MAINE TURNPIKE AUTHORITY

ADDENDUM NO. 3

CONTRACT 2018.20

YORK TOLL PLAZA
MILE 8.8

ITS PLANS - CCTV
GENERAL PLAN AT TOLL PLAZA

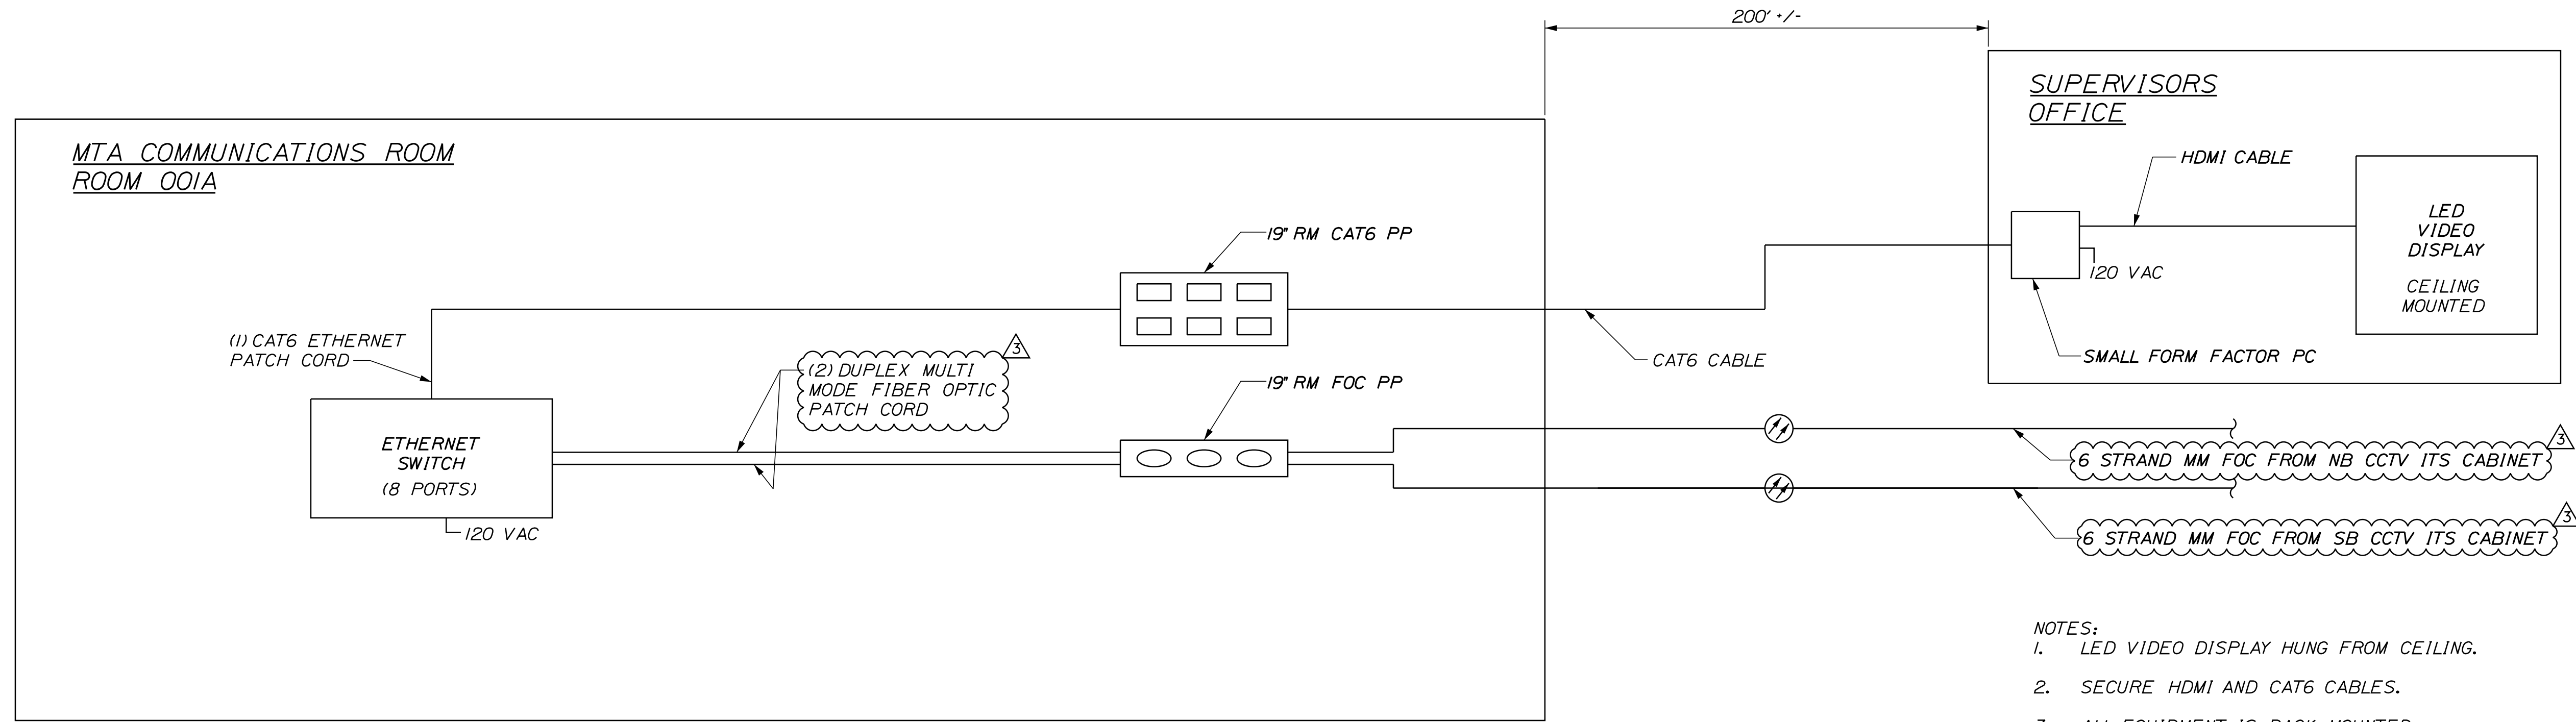
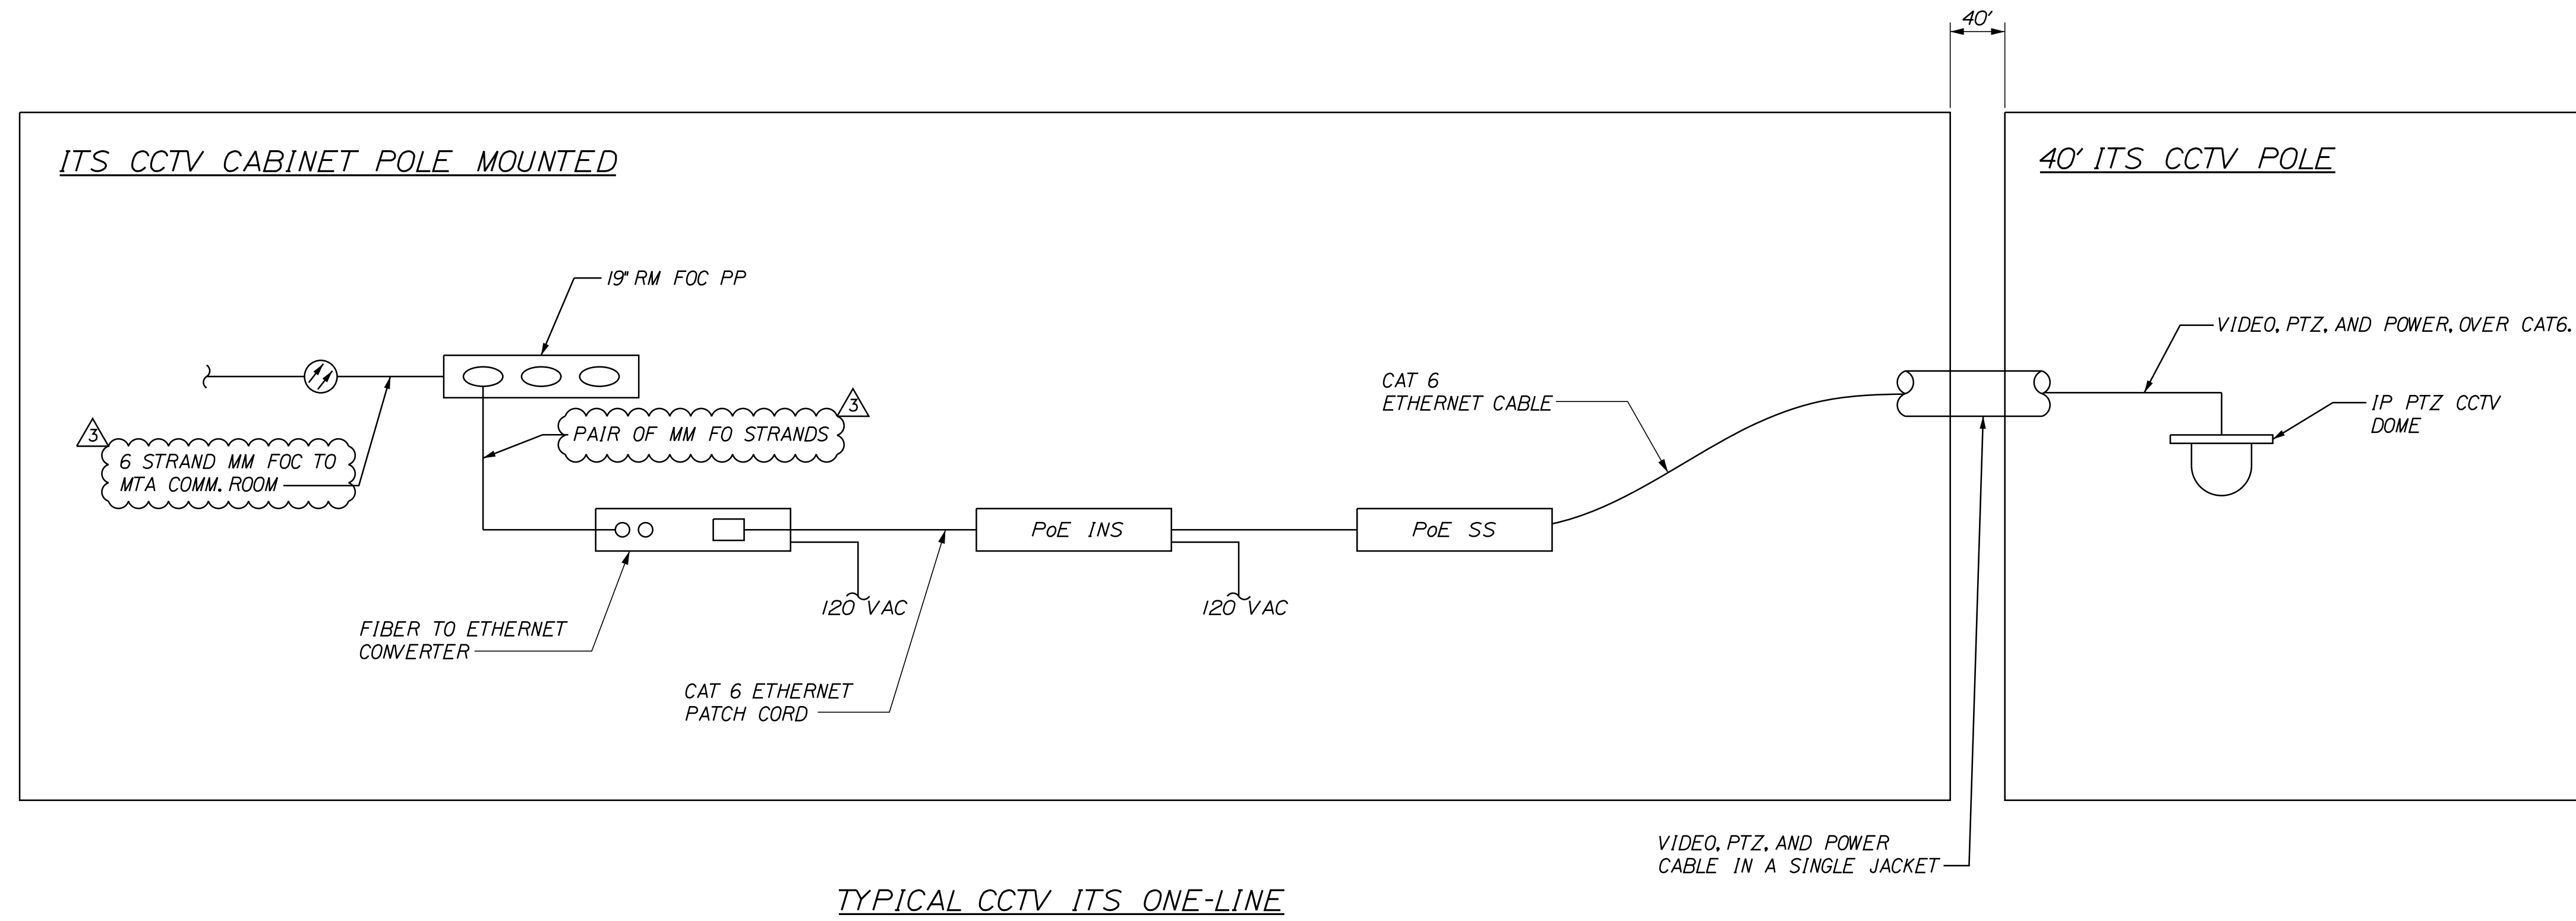
Plan Sheet 455 of 489, “ITS Plans – CCTV - General Plan at Toll Plaza” is deleted and replaced in its entirety with attached revised sheet 426 (Revised 10/4/18). Notes “2” PVC Conduit – Communications (6 Strand SM Fiber)” revised to “2” PVC Conduit – Communications (6 Strand MM Fiber)”.

CCTV ITS ONE-LINE DIAGRAM

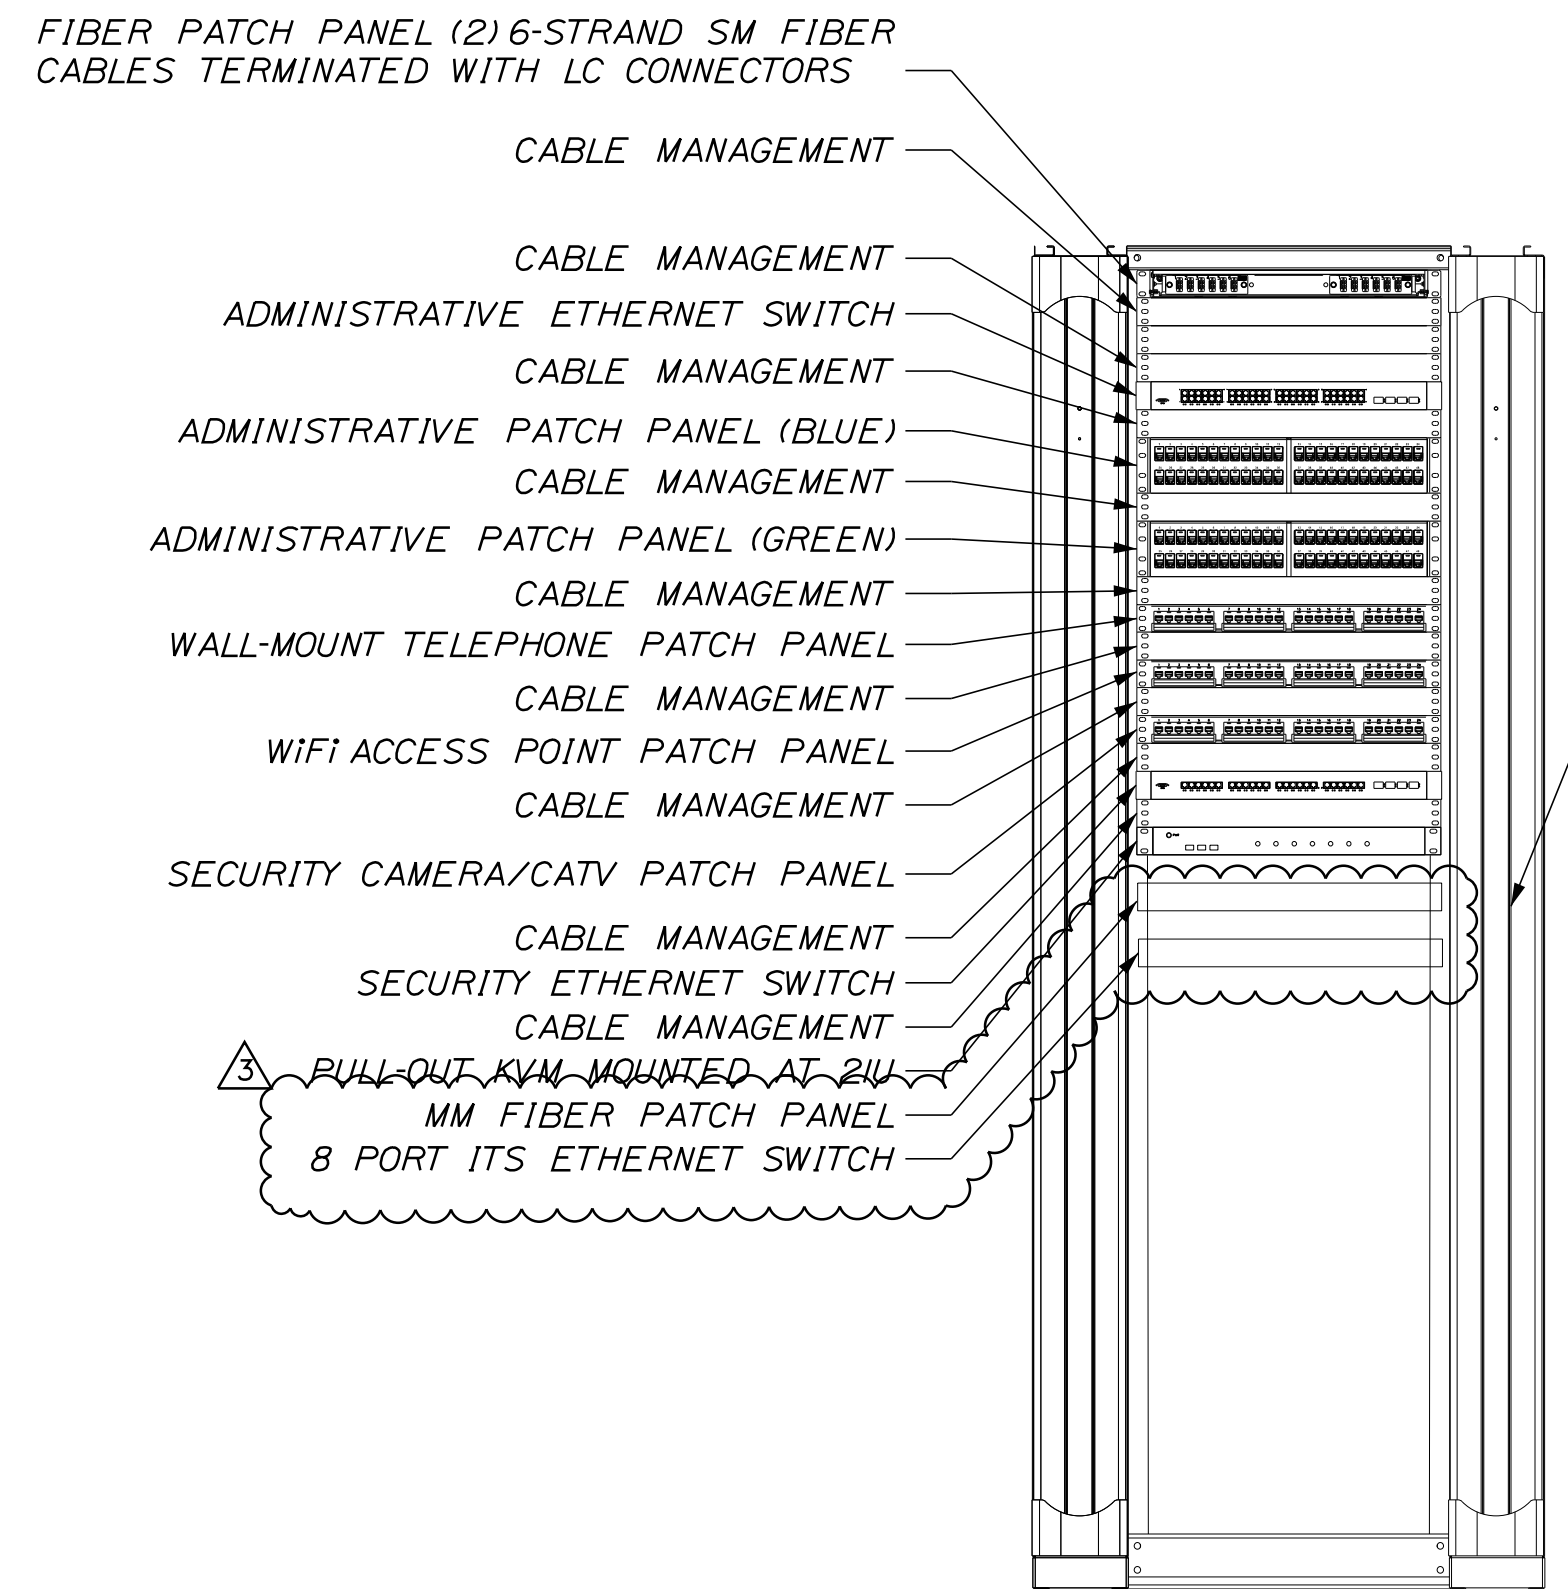
Plan Sheet 456 of 489, “CCTV ITS One-Line Diagram” is deleted and replaced in its entirety with attached revised sheet 456 (Revised 10/4/18). Notes with SM Fiber revised to MM Fiber.
